STUDY OF APPLICABILITY OF RISK REDUCTION MEASURES IN SPATIAL PLANS

Architektonický ateliér Štěpán – Ing.arch. Václav Štěpán

Version 05/2020

II. Part 2 – pilot locality of Lipí and proposed changes to area planning documentation

Collision point Li-1 (village Lipí, cadastral area Lipí):

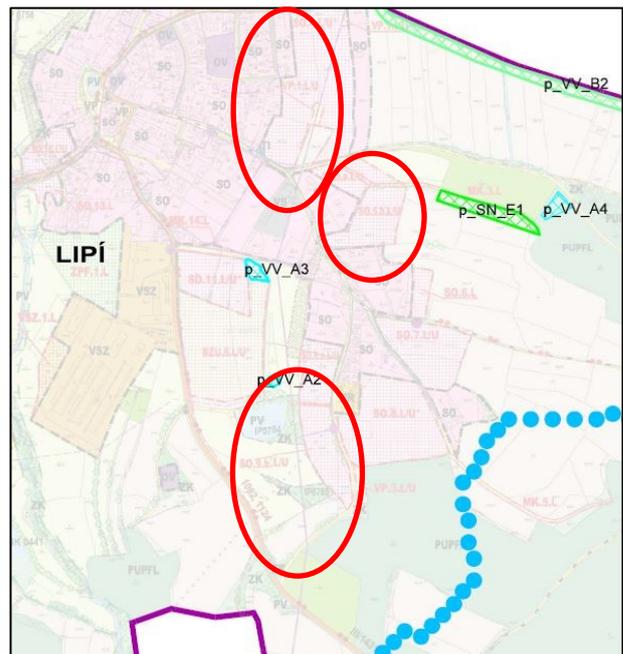
In this case, the collision consisted in the proposal of a protective measure in the form of anti-erosion agrotechnology on arable land, while this proposal interfered with the buildable areas defined in the valid Lipí zoning plan. Specifically, the design of anti-erosion agrotechnology was designed on a part of the area designated by the zoning plan for housing (SO.4.L), then on the area of public space (VP.1.L), and also in this area is the existing 22 kV HV power line.

Place for solving Li-4 and Li-6 (Lipí village, Lipí cadastral area):

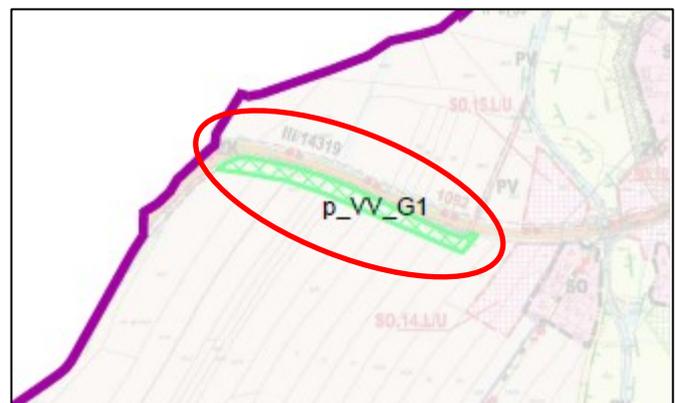
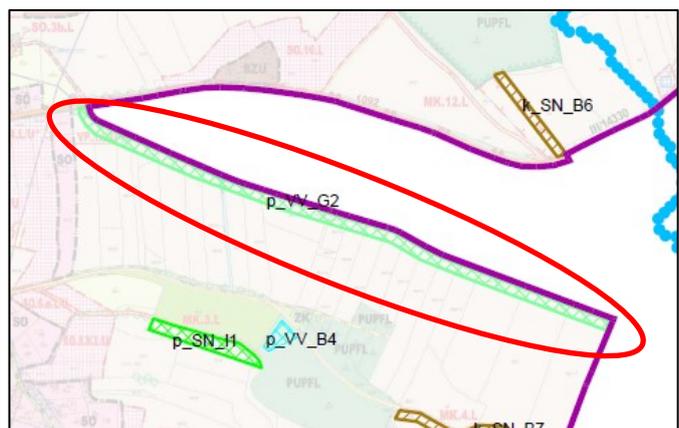
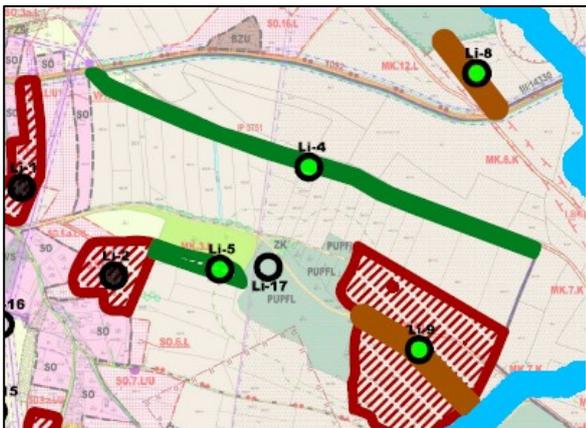
On the territory in the Lipí zoning plan included among the agricultural areas, the T. G. Masaryk Water Research Institute proposed the implementation of a protective measure in the form of protective grassland to ensure flood protection. However, the author of this study, after assessing the area, came to the conclusion that a more appropriate solution to flood risk in this locality would be to modify the flow to a state friendlier to the countryside, especially because some space will be created for landscaping the stream and floodplain to increase the ability environment to slow down runoff and create floodplains that will reduce the potential consequences of surface runoff. Specifically, it is a directional adjustment of the flow, branching of the flow, stabilization of the riverbed or accompanying riparian vegetation. Therefore, for the implementation of the protective measure in question, a water and water management area are proposed in the amendment to the zoning plan - modification of the flow line to a state friendlier to the countryside (p_VV_G1 and p_VV_G2).

Place for solution Li-5 (village Lipí, cadastral area Lipí):

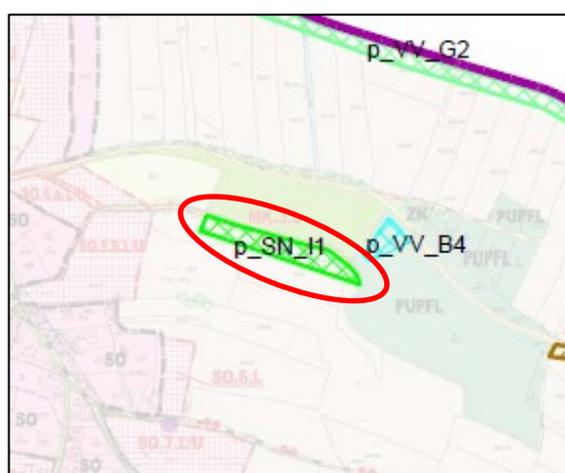
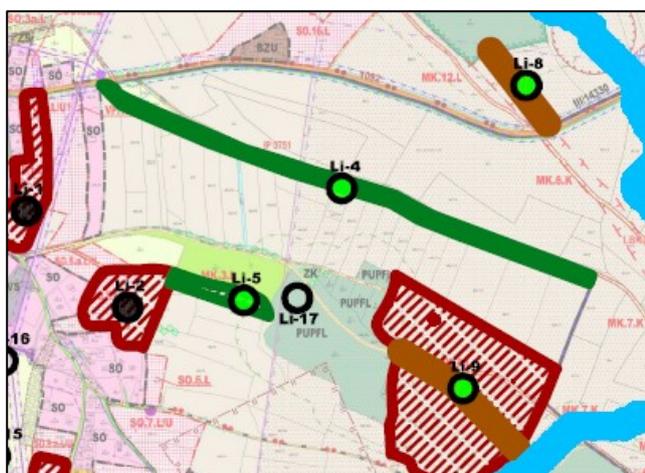
On the territory in the Lipí zoning plan included among agricultural areas, the T. G. Masaryk Water Research Institute proposed the implementation of a protective measure in the form of protective grassland to ensure flood protection. However, after assessing the area, the author of this study came to the conclusion that a more suitable solution to the flood risk in this locality would be to stabilize the concentrated runoff paths, mainly due to easier and more accurate management of water runoff from the surrounding terrain. Specifically, it is a modification of the vegetation in the immediate vicinity of the stream, stabilization of the riverbed or modification of the accompanying riparian vegetation. Therefore, for the implementation of the protective measure in question, a mixed area of undeveloped area - grassing of the valley (p_SN_I1) is proposed in the amendment to the zoning plan.

Place for solving Li-7 to Li-9 (Lipí village, Lipí cadastral area):

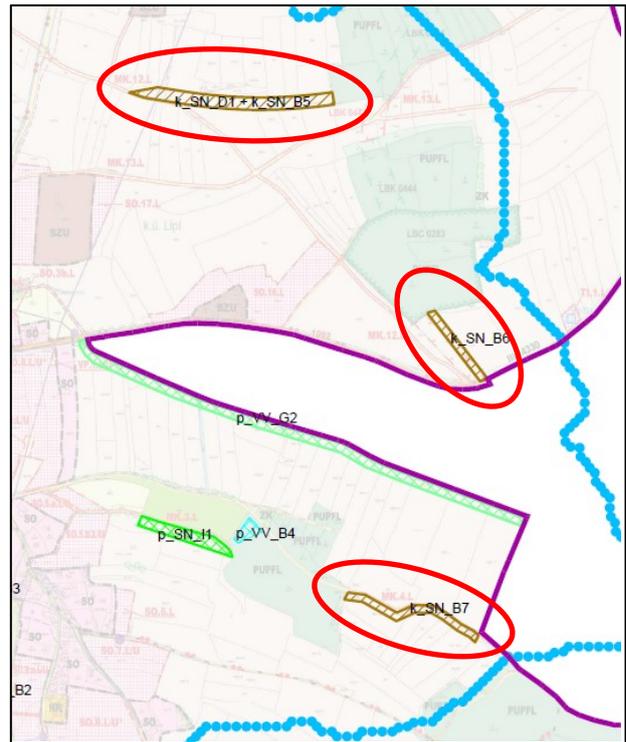
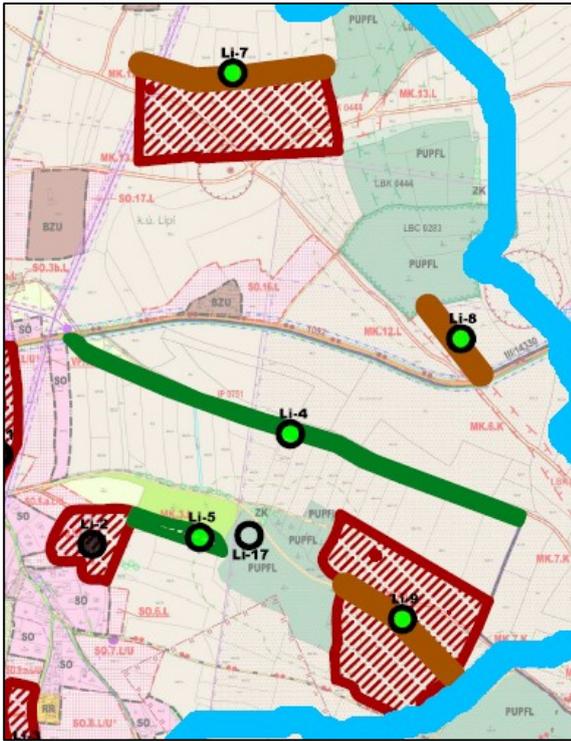
On the territory in the Lipí zoning plan included among agricultural areas, the T. G. Masaryk Water Research Institute proposed the implementation of a protective measure in the form of an anti-erosion field border to ensure flood protection. The author of this study, after assessing the area, agreed with the VÚV proposal, and therefore a mixed corridor of a mixed undeveloped area - limit (k_SN_B5 to k_SN_B7) is proposed for the implementation of the protection measure in question in the amendment of the zoning plan. Within the design, there was only a minor modification of the shape of the proposed corridor (k_SN_B7), according to local conditions in the area. Together with the corridor k_SN_B5, a flood protection measure k_SN_D1 - a gap is proposed in the same route.

Place for solving Li-10 and Li-11 (Lipí village, Lipí cadastral area):

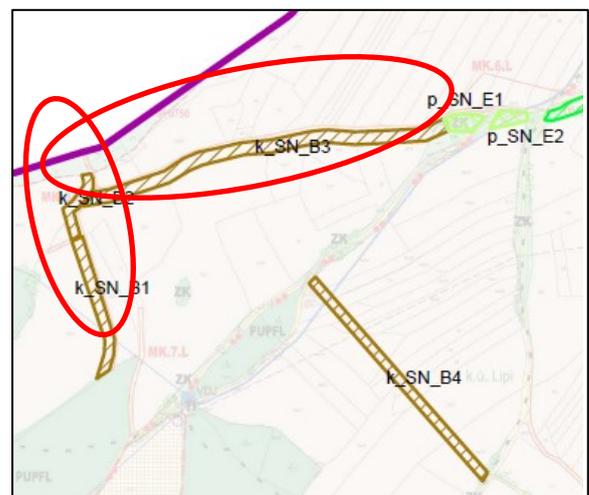
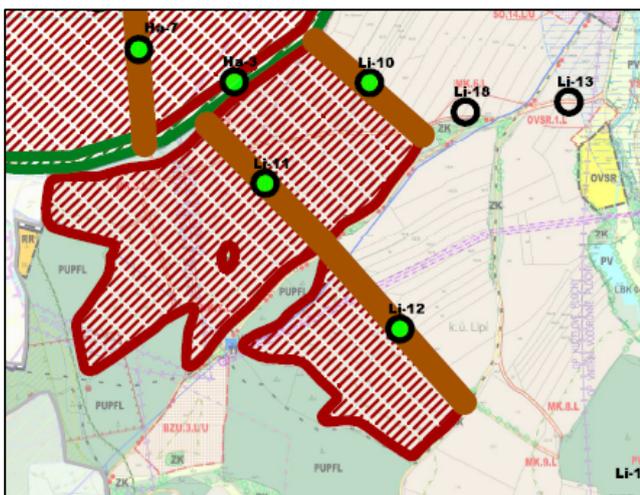
On the territory in the Lipí zoning plan included among agricultural areas, the T. G. Masaryk Water Research Institute proposed the implementation of a protective measure in the form of an anti-erosion field border to ensure flood protection. After assessing the area, the author of this study decided to propose a mixed undeveloped area corridor - a field border (k_SN_B1 to k_SN_B3) in the amendment to the zoning plan, which, however, does not correspond with the shape or location of the measure proposed by the VÚV. This change arose after consultation with the representatives of the municipality and after an examination of the affected area. The new land improvements in cadastral area also contributed to the new location of the proposed measures in Lipí cadastral area.

Place for solving Li-12 (village Lipí, cadastral area Lipí):

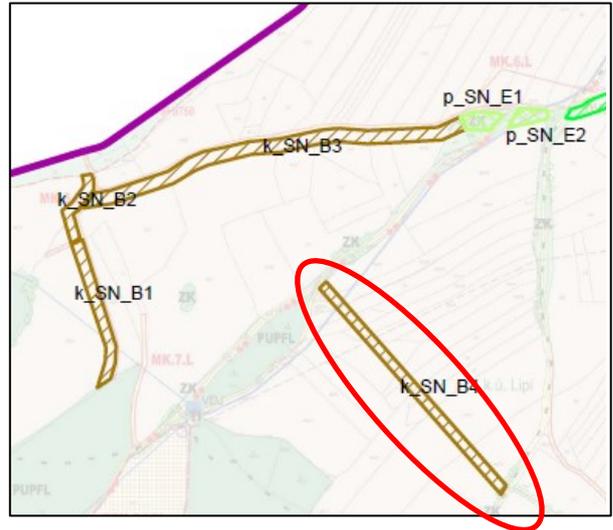
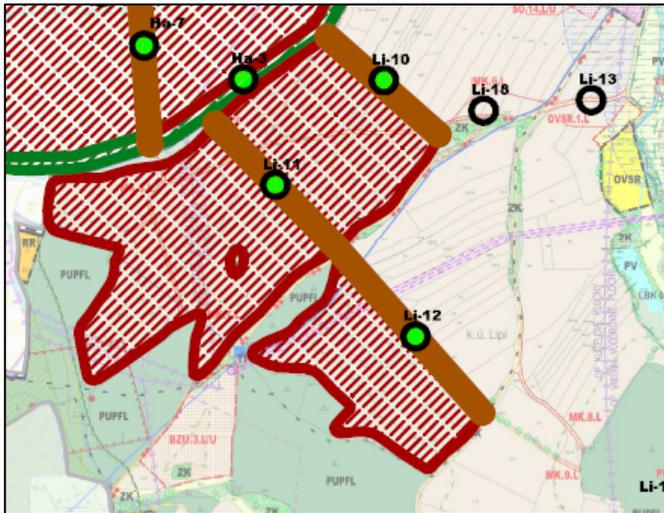
On the territory in the Lipí zoning plan included among agricultural areas, the T. G. Masaryk Water Research Institute proposed the implementation of a protective measure in the form of an anti-erosion field border to ensure flood protection. The developer of this study, after assessing the area, agreed with the VÚV proposal, and therefore a mixed corridor of a mixed undeveloped area – a field border (k_SN_B4) is proposed in the amendment of the zoning plan for the implementation of the protection measure in question.

Place for solving Li-13 (Lipí village, Lipí cadastral area):

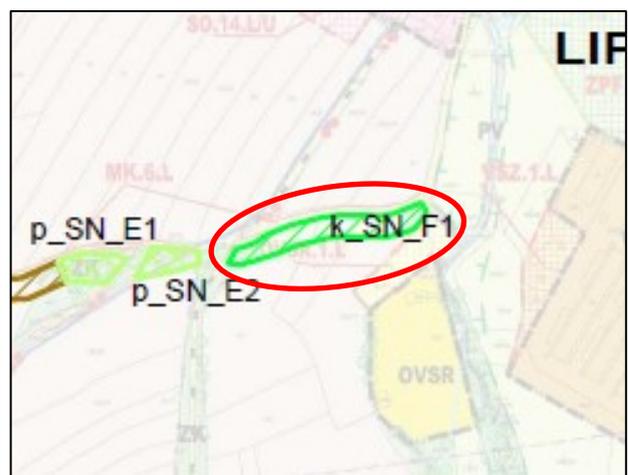
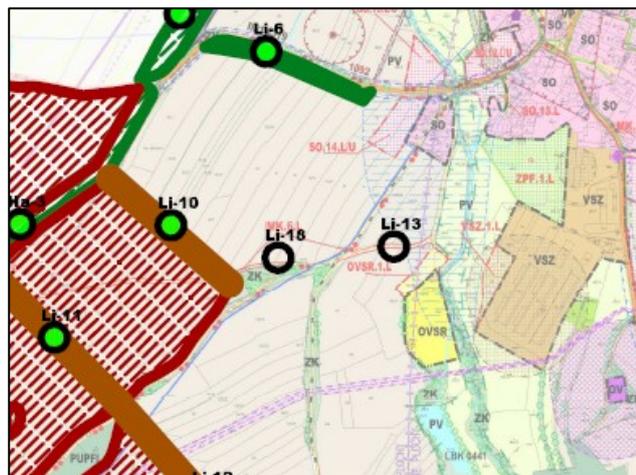
In the area of the Lipí zoning plan included among agricultural areas, a measure to ensure flood protection in the form of a drainage ditch was added. After assessing the area, the author of this study decided to supplement the site in the change of the zoning plan with a mixed undeveloped area corridor - ditch (k_SN_F1), which will help a better drainage of water from adjacent fields and prevent water from torrential rains enter the built-up area of the village.

Place for solving Li-14 (village Lipí, cadastral area Lipí):

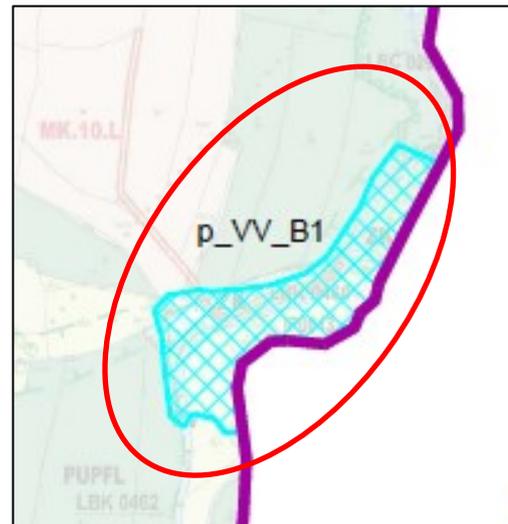
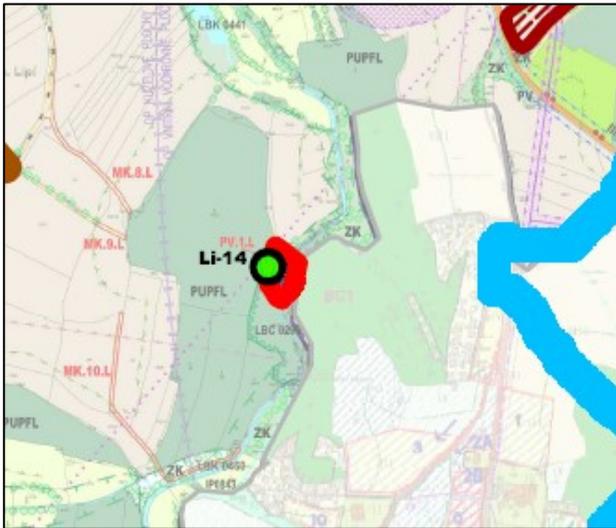
On the territory in the Lipí zoning plan included among water and water management areas, the T. G. Masaryk Water Research Institute proposed the implementation of a protective measure - a small water reservoir (p_VV_B1) to ensure flood protection. After assessing the area, the author of this study decided to propose a new location of the water and water management area - small water reservoir (p_VV_B1) in the amendment to the zoning plan, which does not correspond to the shape or location of the measure proposed by VÚV. This change was made on the basis of a comment submitted after the public hearing and after a thorough examination of the area concerned.

Place for solving Li-15 to Li-17 (Lipí village, Lipí cadastral area):

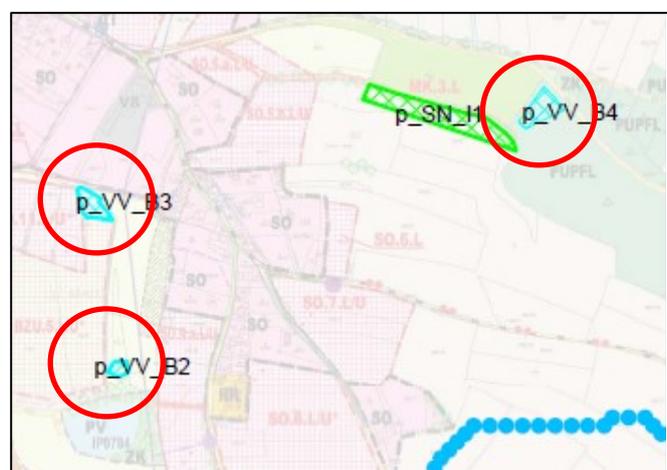
The T. G. Masaryk Water Research Institute did not propose any protective measures to ensure flood protection in the territory of the Lipí zoning plan included between water and water management areas, forest areas, mixed undeveloped areas, agricultural areas and areas of housing in agricultural homesteads. However, after assessing the area, the author of this study came to the conclusion that in order to reduce the flood risk in this locality, it is appropriate to supplement flood protection measures with small reservoirs, mainly due to rainwater and stormwater capture in forest land by creating an interacting biological element in the landscape, which will help, in the event of a drought, by bringing water to the surrounding landscape and creating a quality microclimate. Therefore, for the implementation of the protective measures in question, a small water reservoir (p_VV_B2 to p_VV_B4) is proposed in the amendment of the zoning plan for water and water management areas.

Place for solution Li-18 (village Lipí, cadastral area Lipí):

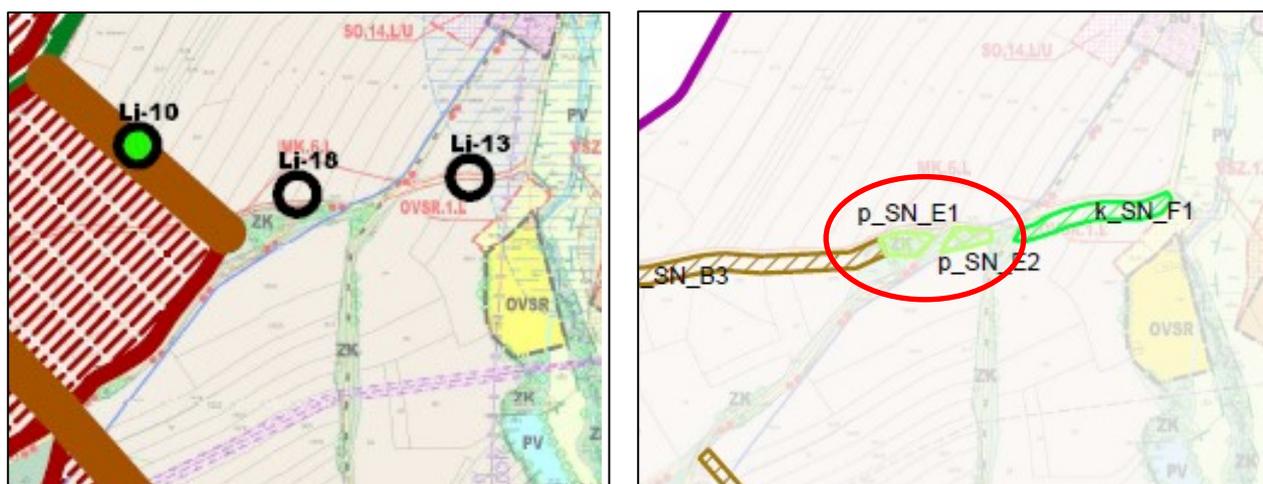
On the territory in the Lipí zoning plan included among the areas of landscape greenery, the T. G. Masaryk Water Research Institute did not propose implementation of any protective measures to ensure flood protection. However, after assessing the area, the author of this study came to the conclusion that in order to reduce the flood risk in this locality, it is appropriate to supplement flood protection measures with elements of dams, especially due to the capture of rainwater and storm water from adjacent agricultural areas. Therefore, for the implementation of the protective measures in question, areas of the mixed undeveloped area - dams (p_SN_E1 and p_SN_E2) are proposed in the amendment to the zoning plan.

Place for solution Hr-1 (village Hradce, cadastral district Hradce u Homol):

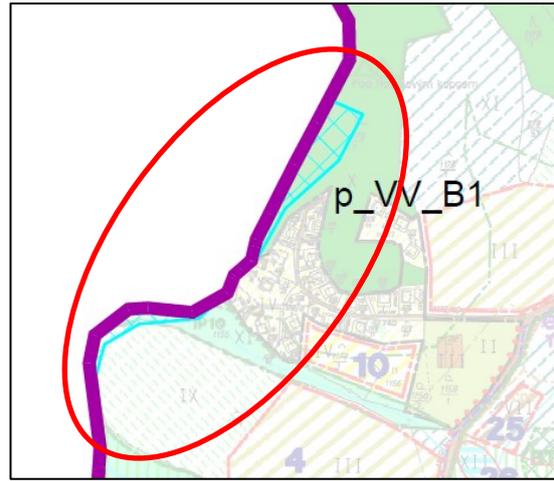
On the territory in the zoning plan of Hradec included between forest areas, natural areas and agricultural areas - the grassland fund, the T. G. Masaryk Water Research Institute did not propose the implementation of any protective measures to ensure flood protection. However, after assessing the area and based on the comments submitted after the public hearing, the author of this study concluded that in order to reduce the flood risk in this locality, it is appropriate to supplement flood protection measures with water and water management area, especially due to rainwater and stormwater capture. from adjacent agricultural areas and their subsequent possible spillage. Therefore, for the implementation of the protective measures in question, a change in the Hradce zoning plan proposes a water and water management area - a small water reservoir (p_VV_B1), which is, however, for the most part located in cadastral area. Lipí and to cadastral area Hradec covers about 1/10 of its total proposed area.

Place for solution SI-3 (village Vrábče, cadastral area Slavče):

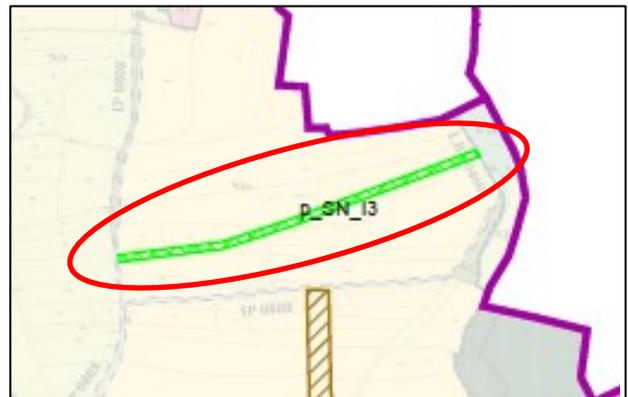
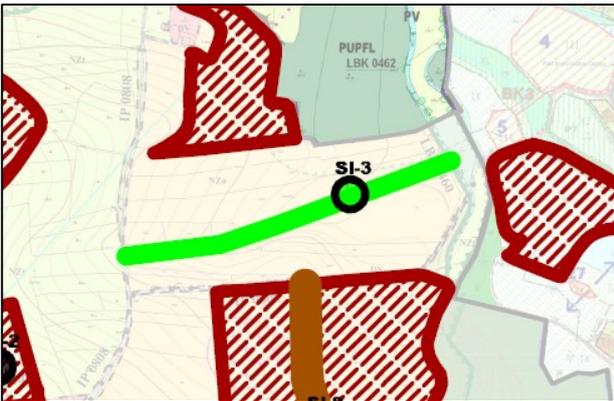
On the territory in the Vrábče zoning plan included among agricultural areas, the T. G. Masaryk Water Research Institute proposed the implementation of a protective measure in the form of an infiltration belt (stabilization of concentrated runoff paths) to ensure flood protection. After assessing the given area, the author of this study agreed with the VÚV proposal, and therefore a mixed corridor of a mixed undeveloped area - grassing of the valley (p_SN_I3) is proposed for the implementation of the protective measure in question in the amendment of the zoning plan.

Place for solution SI-4 (village Vrábče, cadastral area Slavče):

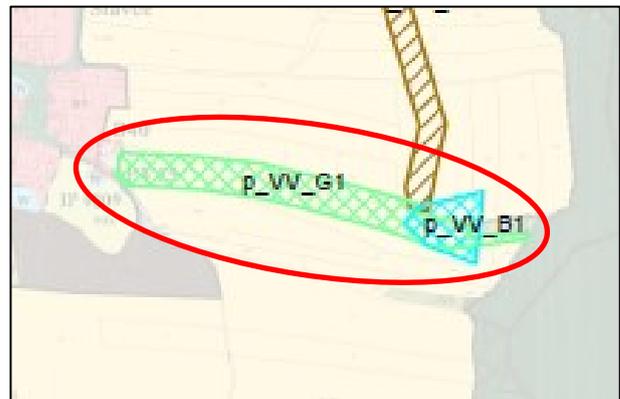
On the territory of the Vrábče zoning plan included among agricultural areas, the T. G. Masaryk Water Research Institute proposed the implementation of a protective measure in the form of protective grassland to ensure flood protection. However, the author of this study, after assessing the area, came to the conclusion that a more appropriate solution to flood risk in this locality would be to modify the flow to a nature close to it, especially because some space will be created for landscaping the stream and floodplain to increase the ability environment to slow down runoff and create floodplains that will reduce the potential consequences of surface runoff. Specifically, it is a directional adjustment of the flow, branching of the flow, stabilization of the riverbed or accompanying riparian vegetation. Therefore, for the implementation of the protection measure in question, a water and water management areas are proposed in the amendment to the zoning plan - modification of the flow line to a state friendlier to the countryside (p_VV_G1).

Place for solving SI-5 and SI-6 (village Vrábče, cadastral area Slavče):

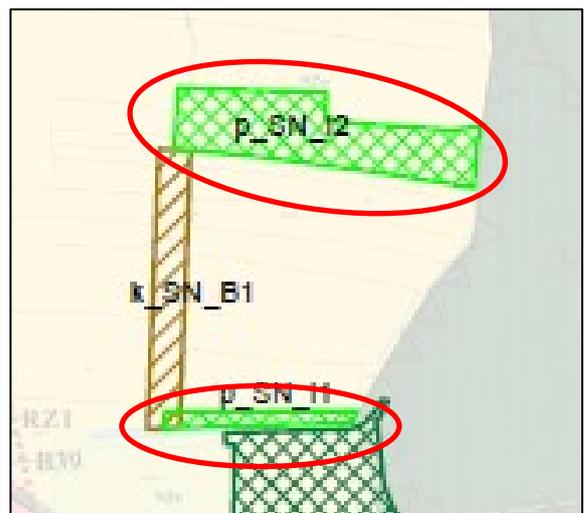
On the territory of the Vrábče zoning plan included in the agricultural areas, the T. G. Masaryk Water Research Institute proposed the implementation of a protective measure in the form of protective grassland to ensure flood protection. However, after assessing the area, the author of this study concluded that a more suitable solution to the flood risk in this locality would be to stabilize the concentrated runoff paths, mainly due to easier and more accurate management of water runoff from the surrounding terrain. Specifically, it is a modification of the vegetation in the immediate vicinity of the stream, stabilization of the riverbed or modification of the accompanying riparian vegetation. Therefore, for the implementation of the protective measure in question, a mixed area of undeveloped area - grassing of the valley (p_SN_I1 and p_SN_I2) is proposed in the amendment to the zoning plan.

Place for solution SI-7 (village Vrábče, cadastral area Slavče):

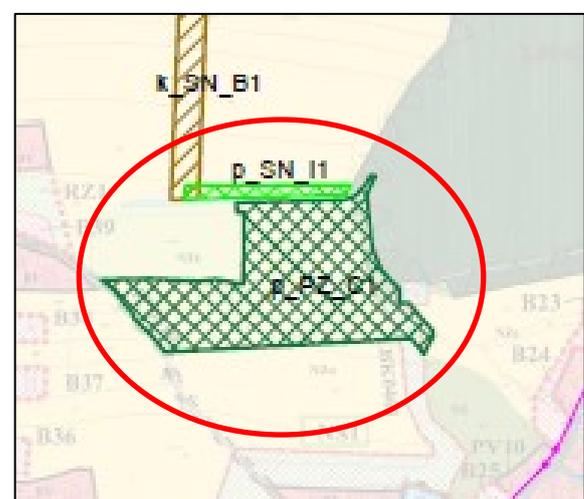
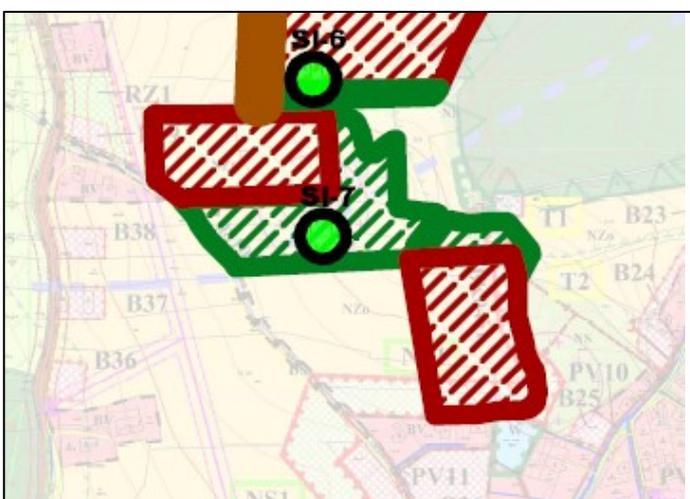
On the territory of the Vrábče zoning plan included among agricultural areas, the T. G. Masaryk Water Research Institute proposed the implementation of a protective measure in the form of protective grassland to ensure flood protection. From the assessment of the given area, the author identifies with the VÚV proposal, but he proposed the transformation of arable land into an area of permanent grassland, which will enable a better creation of conditions for the implementation of the proposed protective grassing. Therefore, for the implementation of the protective measure in question, the area of the measure - the area of grassing (p_PZ_C1) is proposed in the amendment to the zoning plan.
